**Project Background**

The property in question is a 2.45-acre parcel located on the west side of Darrow Road. The property is located in District 7 – Office Overlay and owners purchased the property in 2021.

The applicant is requesting a variance of twenty-two (22) square feet from the required maximum permanent ground sign area of forty (40) square feet resulting in an area of (62) square feet in order to construct a permanent ground sign.

### 25-430

(1) Non-Illuminated Cabinet

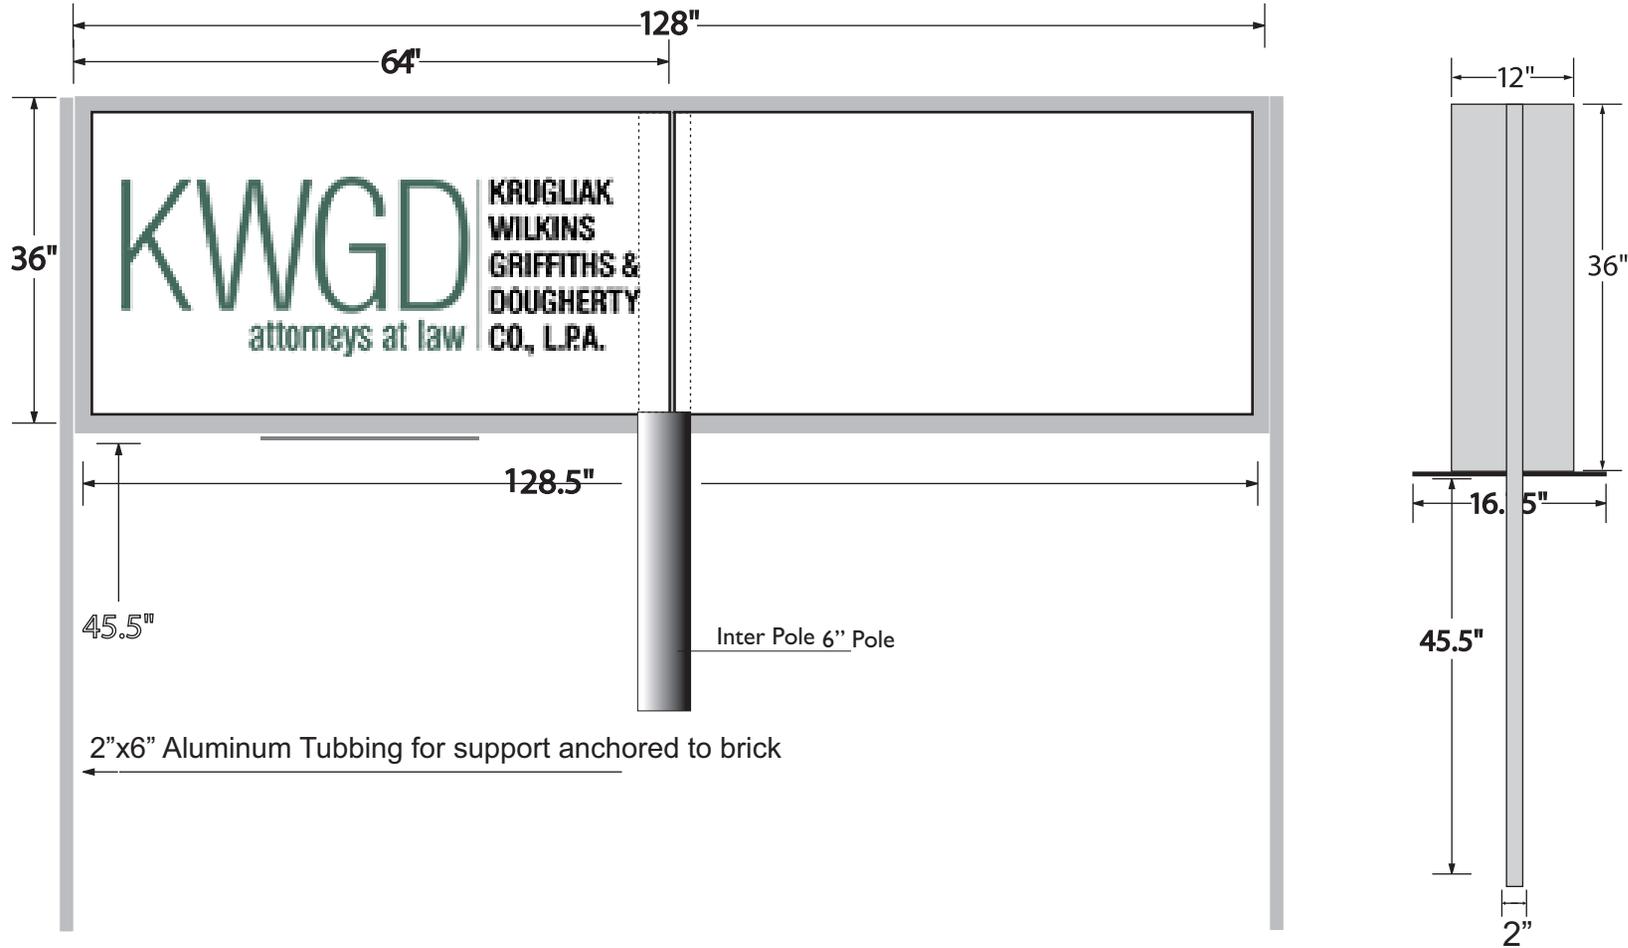
The variance request would represent a 55% increase over the maximum allowable area for permanent ground signs within the city.

Staff notes that the applicant could utilize the existing ground sign. Staff recommends that the applicant consider reconfiguring the existing sign to accommodate all three business on site. This approach would maintain LDC compliance while meeting the applicant's signage needs.

Staff Comment: The submitted application does not demonstrate a practical difficulty per the above criteria.
